**Consumers
Power
Company**

RELATED CORRESPONDENCE

Attached are copies of audit reports and of certain other documents recently issued by the MPQAD.

AUDIT REPORTS

DETAIL 12

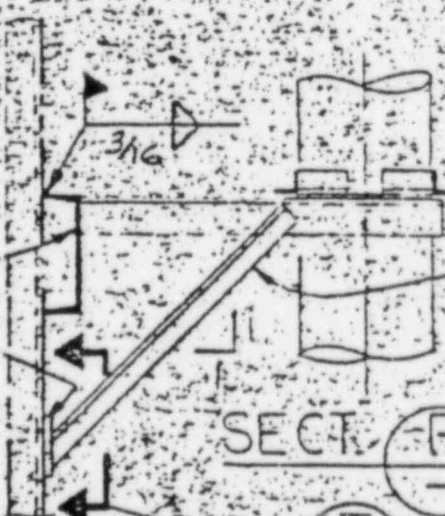
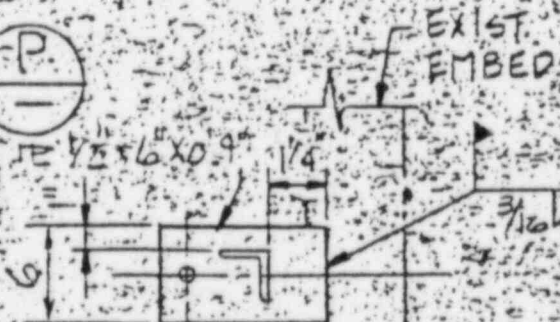
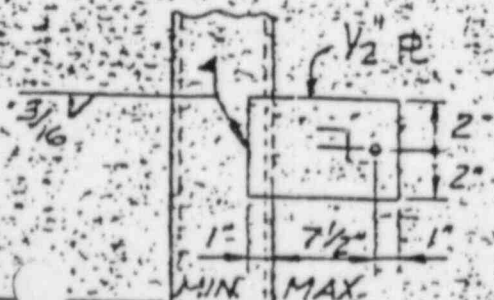
12 REQUIREMENT
 Item #1: 7220-M-151A(Q) REV. 15 SECTION 10.2.1 STATES: DUCT, HANGERS & SUPPORTS shall be fabricated as shown on the drawings. Drawing 7220-DETAIL 7/C849 Rev. 12.
 Item #2: 7220-M-151A(Q) Rev. 15 Section 16.7 States: Subcontractor's Plans and procedures shall include the means by which Subcontractor ensures that work is COMPLETE and correct prior to Subcontractor's request for inspection by MPQAD. See Continuation Sheet Page 2

DETAIL 13
C-892

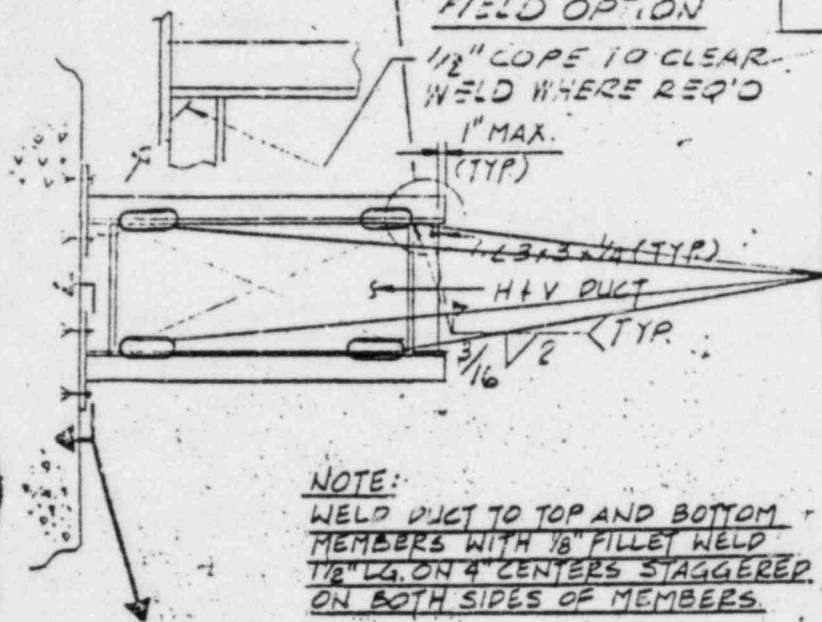
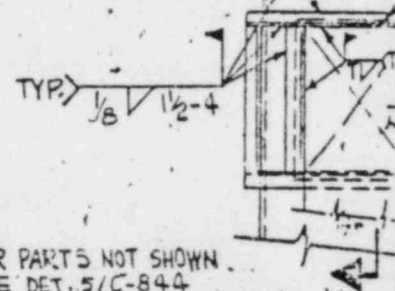
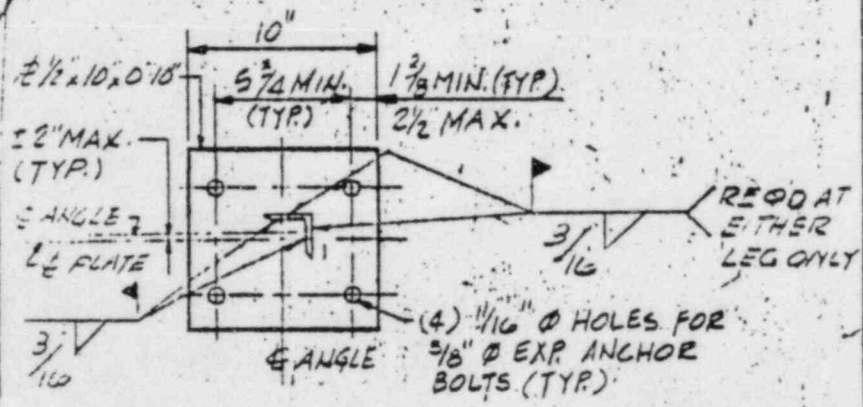
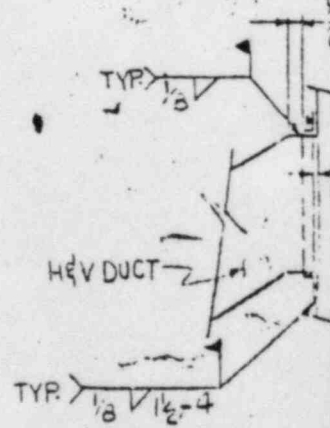
12 REQUIREMENT 7220-M151A(D) Rev. 15 Section 10.2.1 States: Duct hangers and supports shall be fabricated as shown on the drawings. Drawing 7220-C-892 Rev. 9 detail 13 requires, Weld duct to top and bottom members with 1/8" fillet weld 1/2" long on 4" centers staggered on both sides of members. This NCR is being written on previously accepted item (a. iv.) Hanger to duct welds on PIPR H-7-A #1413 dated 12-6-82 per the above criteria.

29 CAUSE HANGER TO DUCT WELDS ^{PWD} 10-11-83 REQUIREMENTS ON
DETAIL 131C-892(Q) WERE MISINTERPRETED AND THUS WELDS
WERE NOT INSTALLED TO DETAIL. THESE WELDS WERE INAD-
VERTENTLY ACCEPTED BY MPOAD.

DETAIL 7
1" = 1'-0" C929

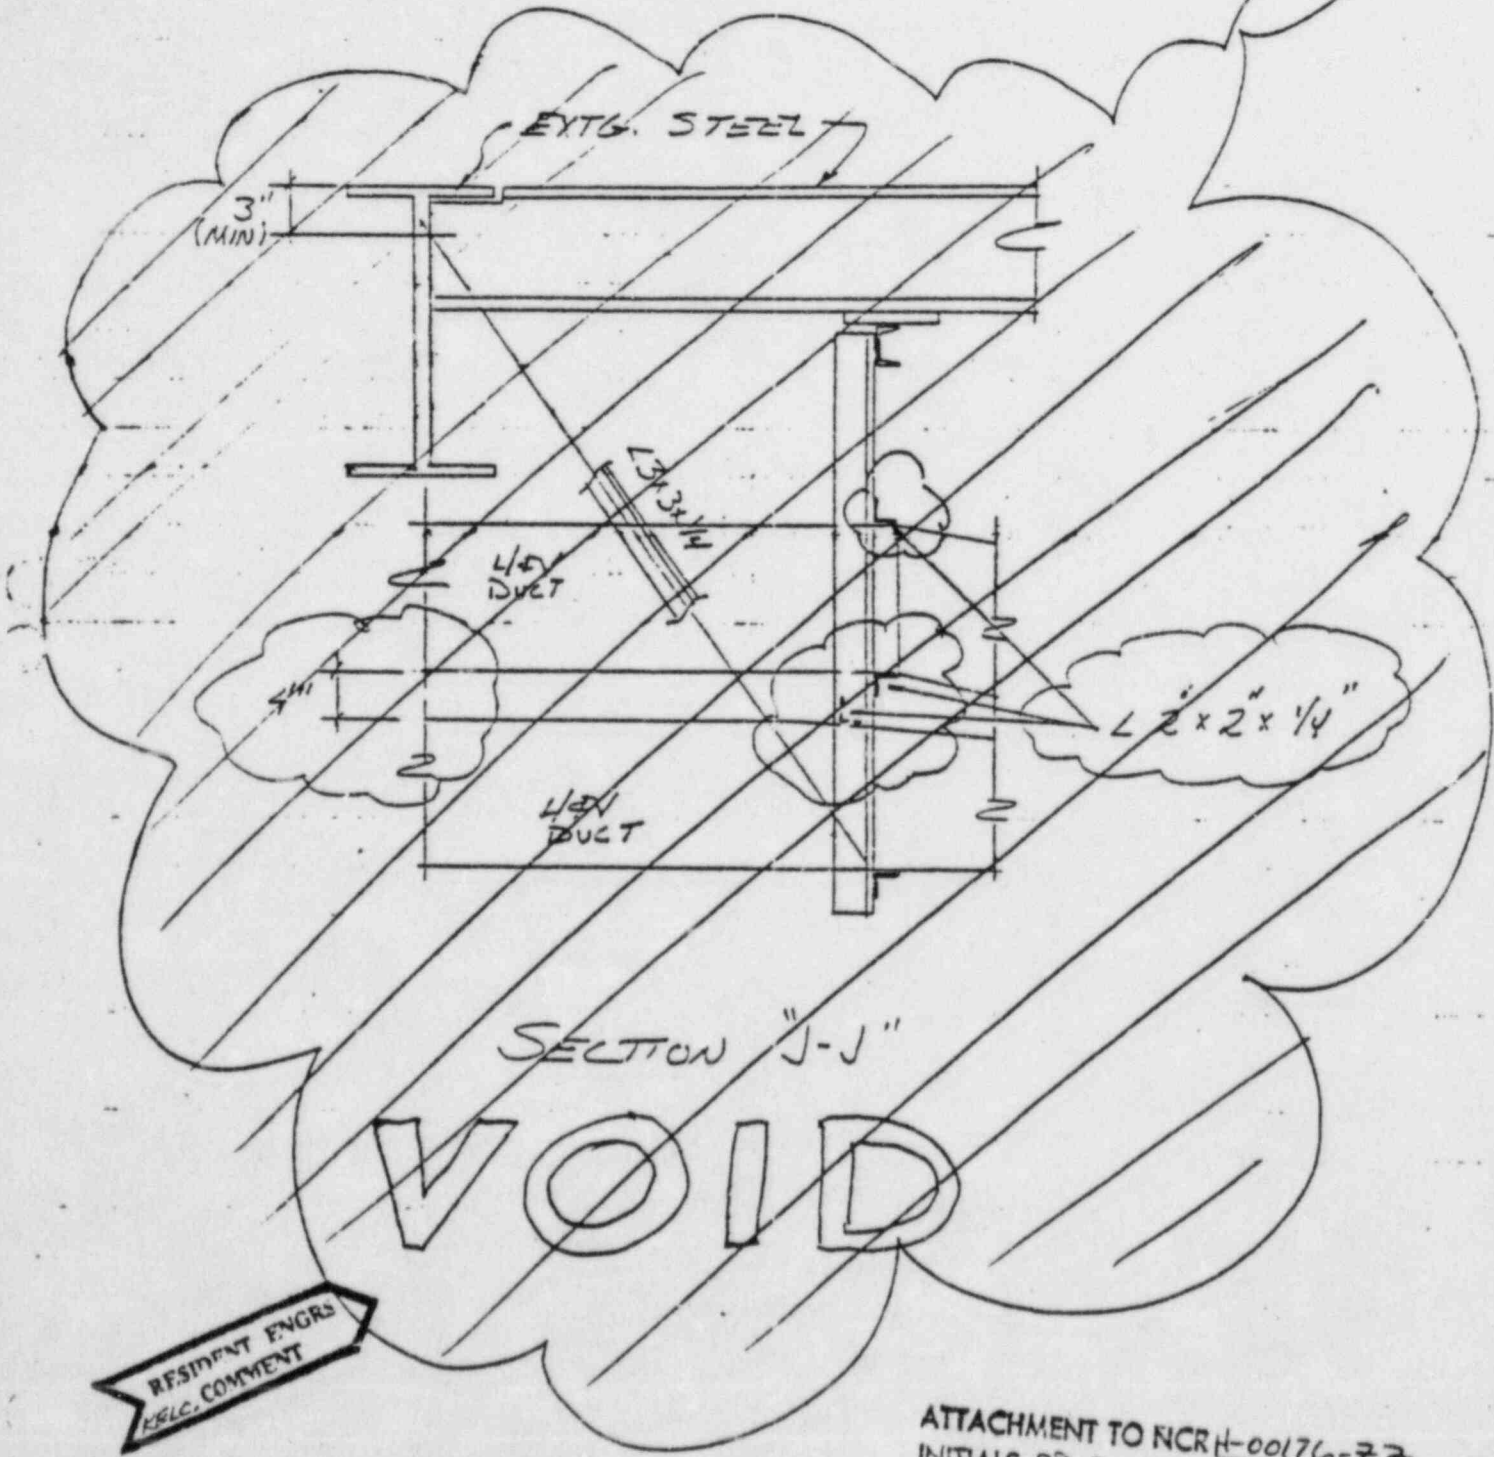
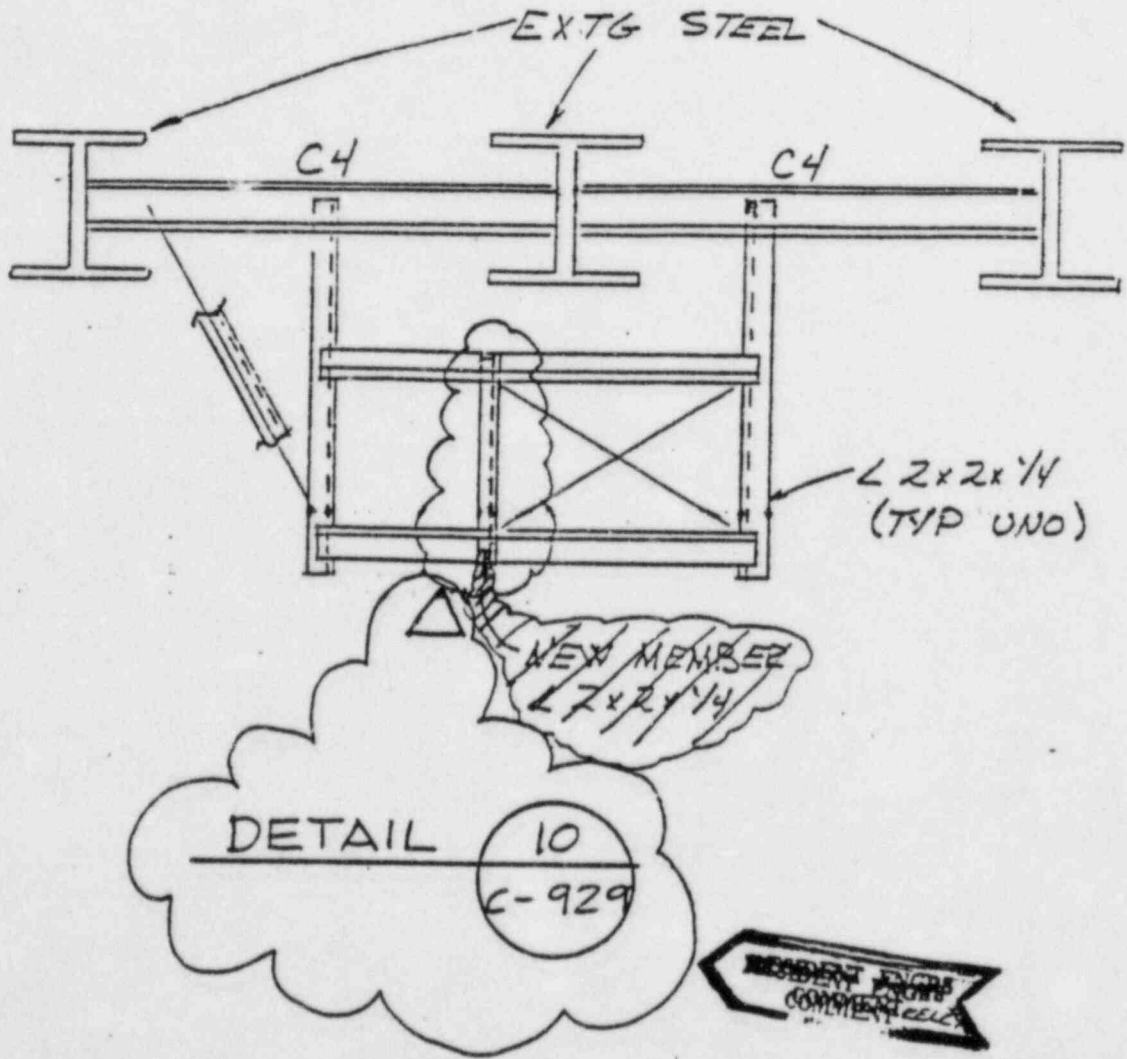
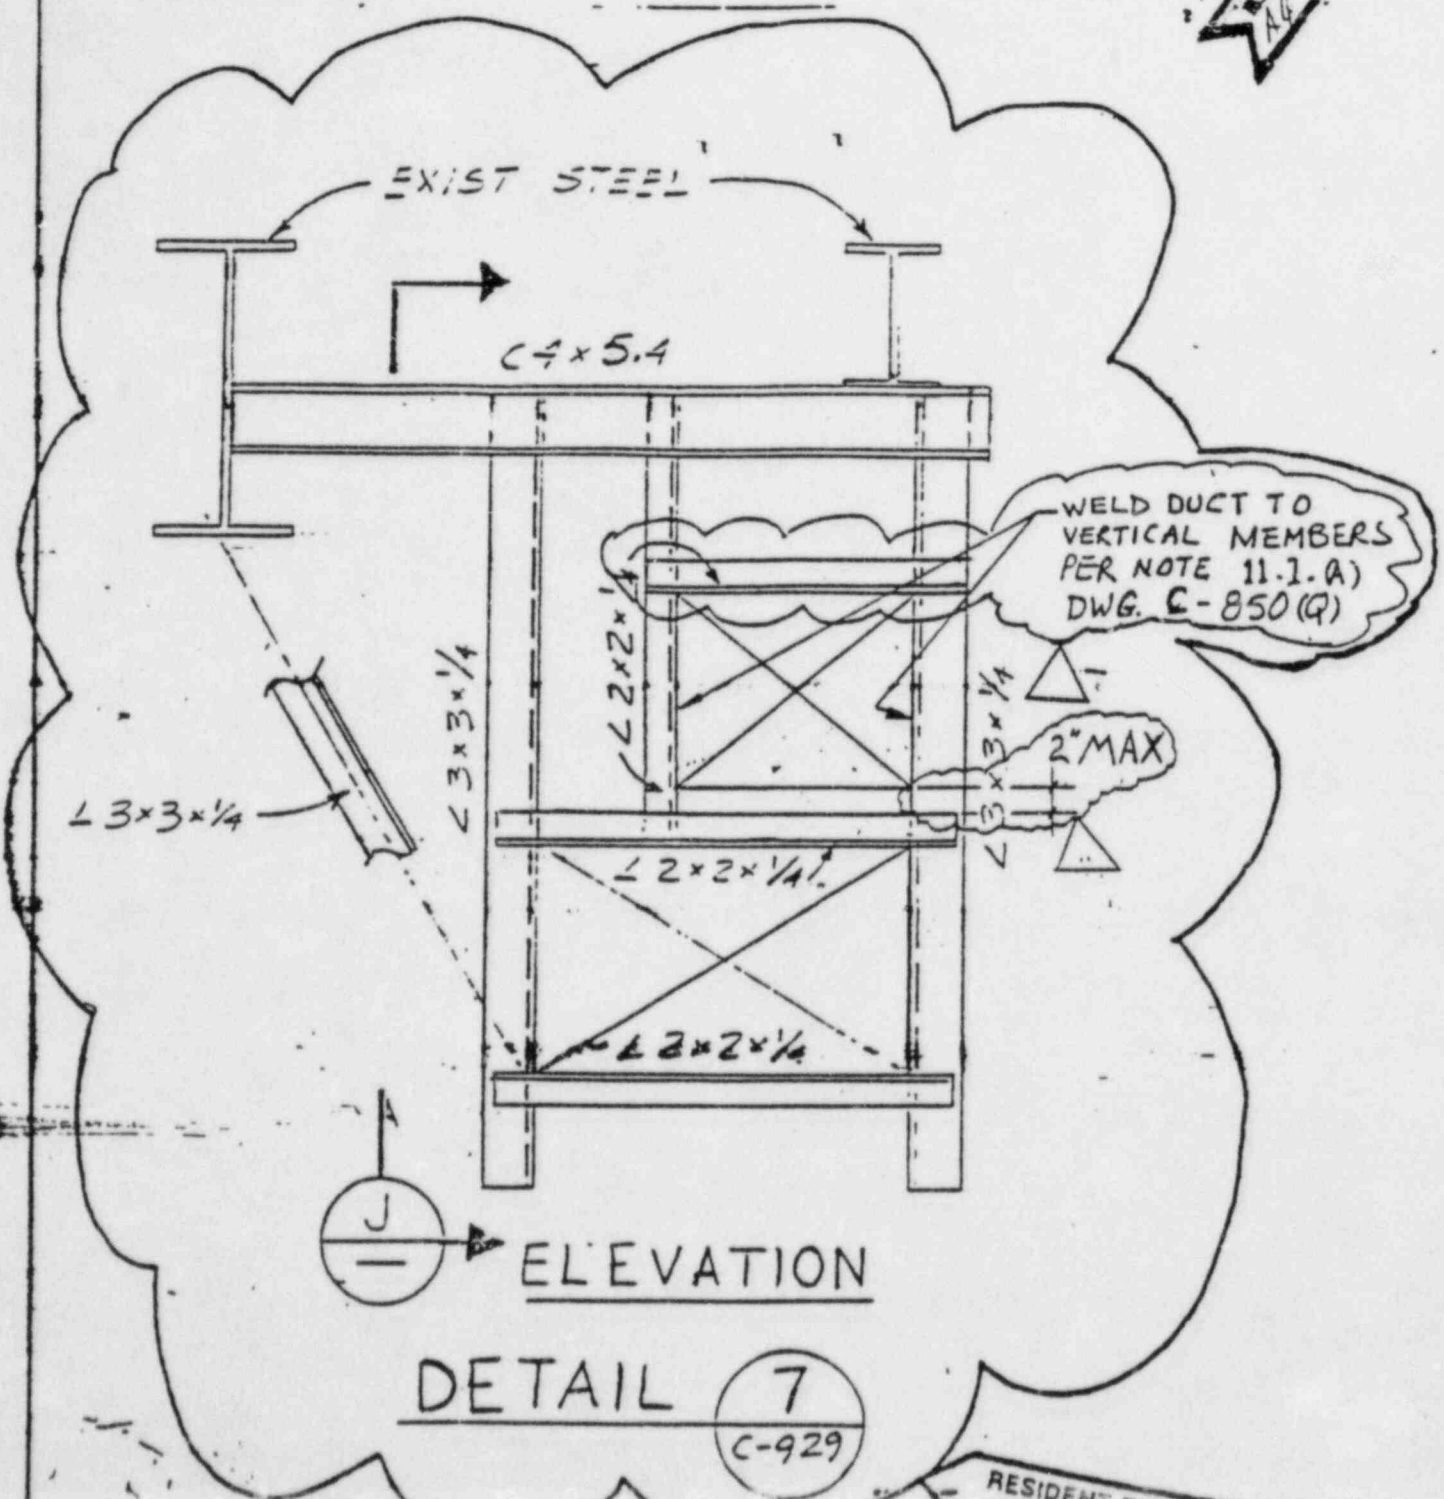
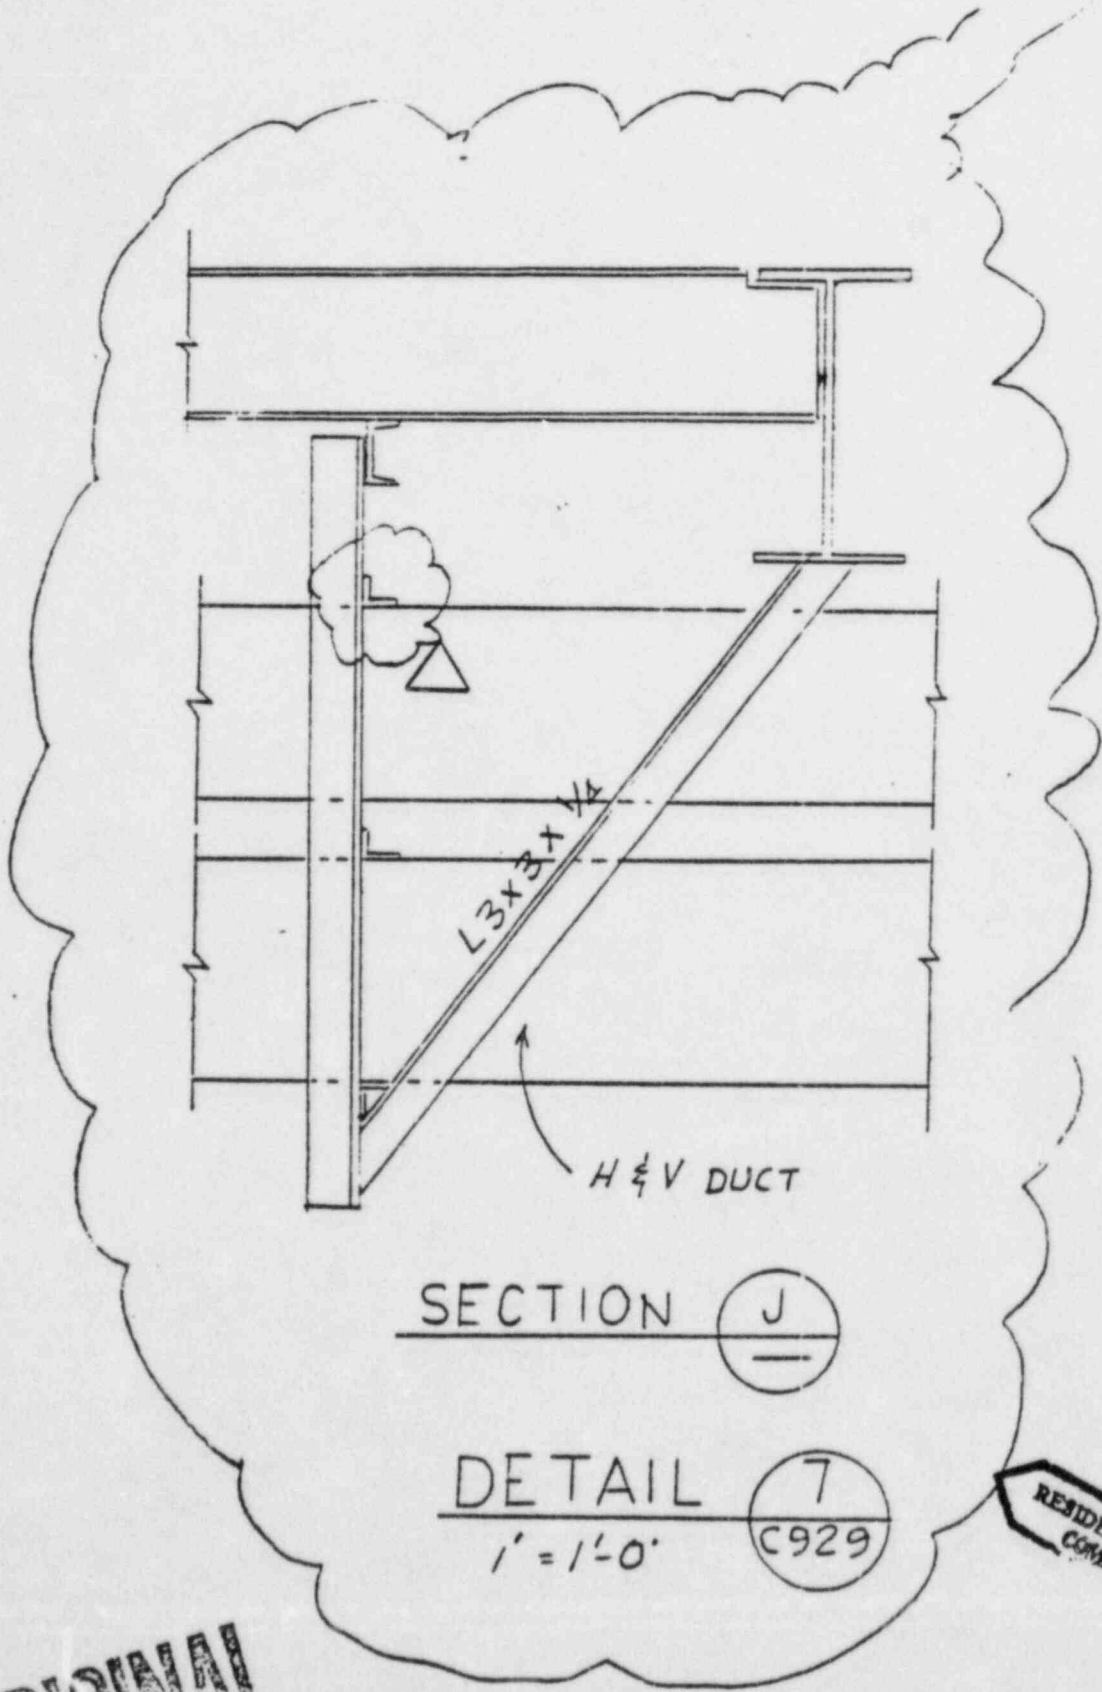
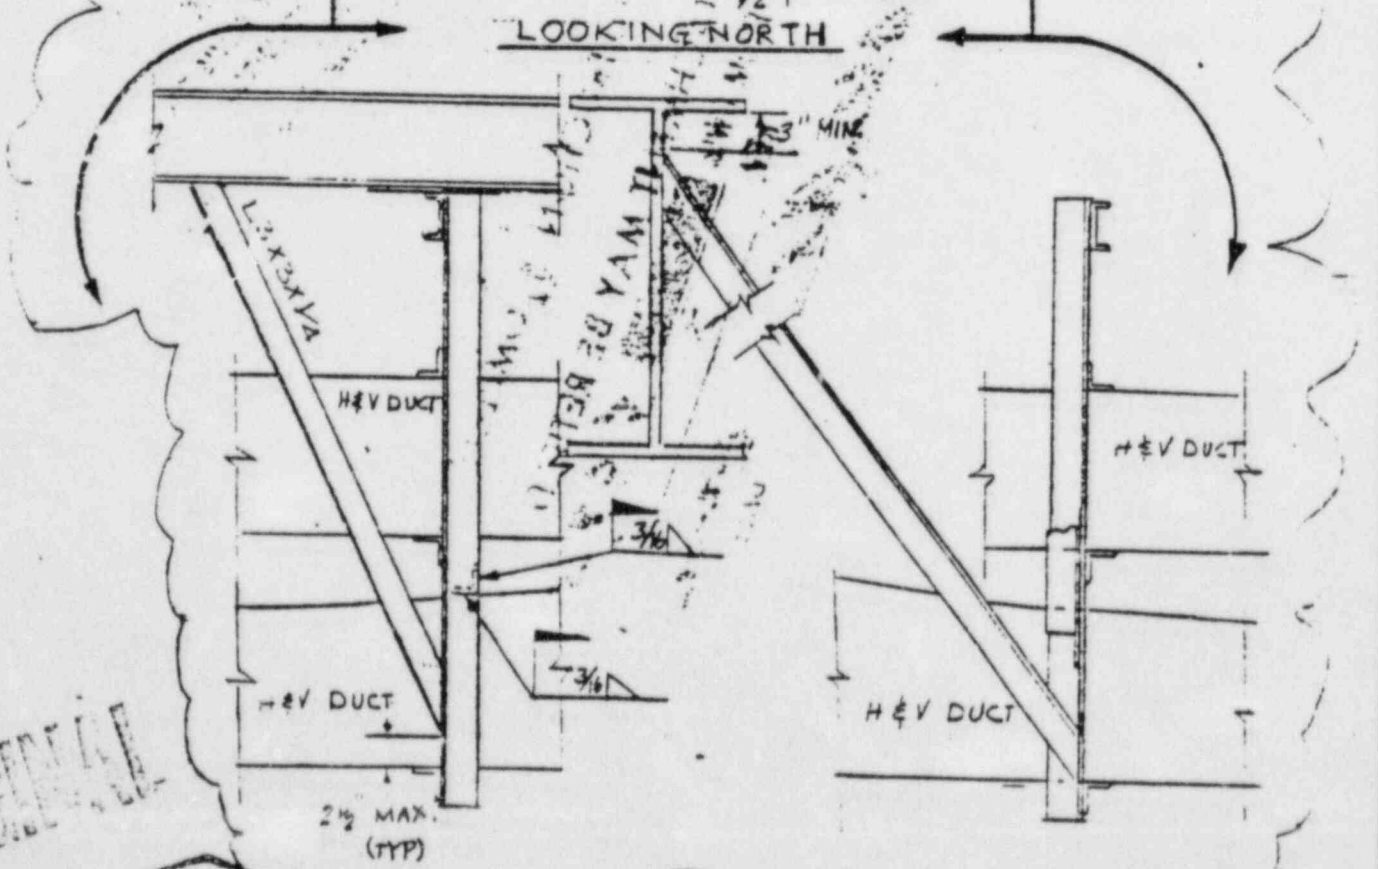
Contrary To The Above Requirements FCN C-878 Notes Revisions To Be Made To Plan Drawing C-935(Q) But The Changes Have Not Been Incorporated.

DESCRIPTION OF CHANGE
SEE DRAWINGS REV. 3
1. PAGE 2 THIS FCN IS VOID.
2. REVISE DWG. C-929(Q) PER PAGES 3, 4 & 5 THIS FCN
ATTACHMENT TO NCR H-00176-22 INITIALS PSC DATE 12/18/83 PG. 3 OF 89
ON PLAN DWG. C-935(Q) REV. 3 APPROX. LOC. 39'-8" E / 1/2" OF RB1 AND 33'-7" S / 1/2", CHANGE CALLOUT TO READ:
7 REVISE PER C-929 FCN C-818 SHT. 6
RESIDENT ENGRS COMMENT

REMARKS APPROVED WITH COMMENTS. DRAWING C-929 (Q) WILL BE REVISED. NO DRVC ISSUED. BC
Tel. 625-2500 AQ 12/30/81
